SUNDRY NOTICES AND REPORTS ON WELLS

Shogrin 12 Fed #1

30-025-29876

- ☐ Abandonment  
☐ Recompletion  
☐ Plugging Back  
☐ Casing Repair  
☐ Altering Casing  
☒ Other **Plug & Abandonment**

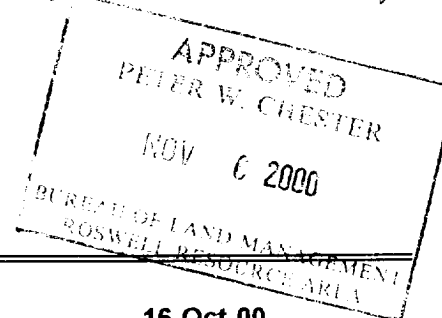
- 1) Set CIBP @ 8,080' w/35' cmt on top. Circ 10# mud.
- 2) Set 100' cmt plug @ 5,042'.
- 3) Cut & pull 5 1/2" csg @ approximately 2,000'. *2160' - 1950'*
- 4) Set 100' plug @ ~~2,050', 50' in 50' out of casing~~. Tag.
- 5) Set 100' plug @ 452'.
- 6) Set 10 sxs cement plug @ surface & install dry hole marker.

*See attached*  
GWN
